From: Andy Gibbs <Andy.Gibbs@foremanhomes.co.uk>
Sent: 07 June 2023 13:32
To: Morris, Rachael
Subject: Re: F/23/95151 – proposed erection of 1No. 3 bedroom dwelling with associated amenity space and parking – land rear of Saxon Court, The Barn, Burnetts Lane, Horton Heath

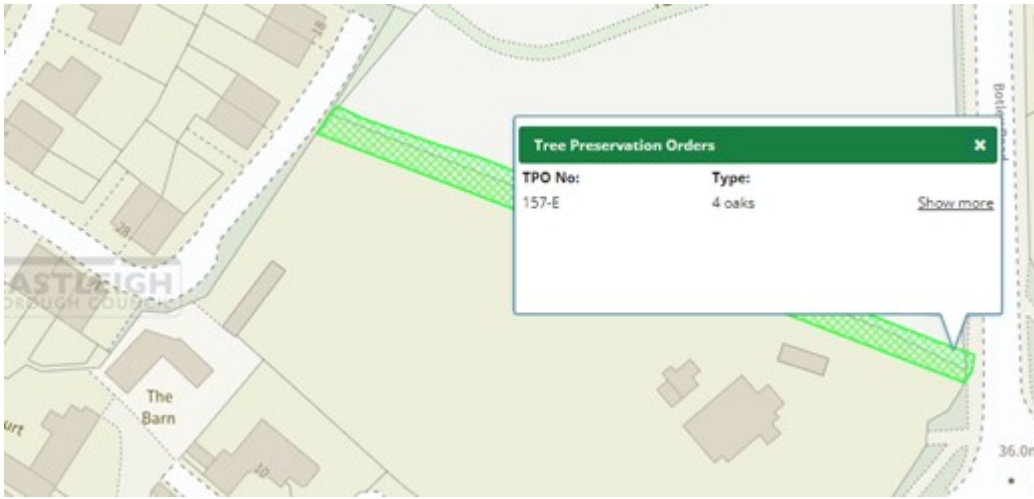
As a starting point, I ought question its overall validity: the proposal's 'red-line' does not show a connection to a public/adopted highway – as the road through which they are seemingly wishing to gain access is a private road – and, as such, the red-line should encompass such within its entirety, and notice ought also be served upon ourselves as its owner; as such, and until this matter is rectified, the application ought be returned, undetermined, as to proceed any further would put any other council-decision at considerable risk of legal challenge. Indeed – and in an effort to be helpful – I have marked up (albeit very crudely below), the extent to which I do believe the 'red-line' should be extended:
